DRAFT 11 DRAFT

Thank you for the opportunity to comment on the proposed revisions to the CPSC Handbook for Public Playground Safety. The Early Childhood Education Linkage System (ECELS) of the Pennsylvania Chapter, American Academy of Pediatrics provides health and safety materials, technical assistance and training to child care facilities and child care licensing staff in Pennsylvania and we use the CPSC Handbook regularly as a resource.

Comments on Proposed Revisions to CPSC Handbook for Public Playground Safety

12.3, particularly the figure 16 showing the automobile tire at the contact point of each end of the seesaw.

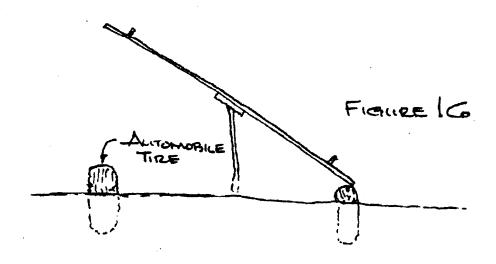
Suggestion: Show the tire beneath the surfacing in the diagram. Many people have not understood that you must bury half of the tire and leave the other half exposed to provide the cushion.
